REMARKS

Drawing Objections

FIG. 8B

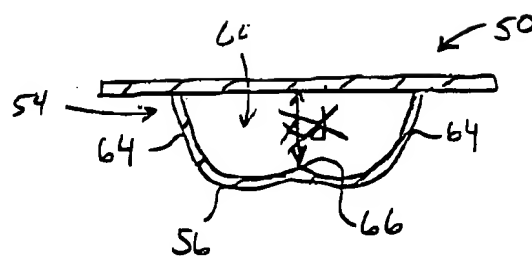
The Drawings were objected to because reference numerals 54 and 60 were not shown in the drawings and because references A, B, Z, and d were not mentioned in the specification. Attached please find a proposed drawing correction showing the reference numerals 54 and 60 added to Figure 8B. "A" and "B" are discussed in the "BRIEF DESCRIPTION OF THE DRAWINGS" brief drawing section for Figures 8A and 8B respectively. Applicant can not locate "Z" in the drawings. "d" has been removed in the proposed drawings. This drawing correction was provided in Applicant's previous response, but a copy of the red-ink version could not be included because the response was submitted by facsimile. The Examiner is requested to consider the proposed changes which have been set forth above.
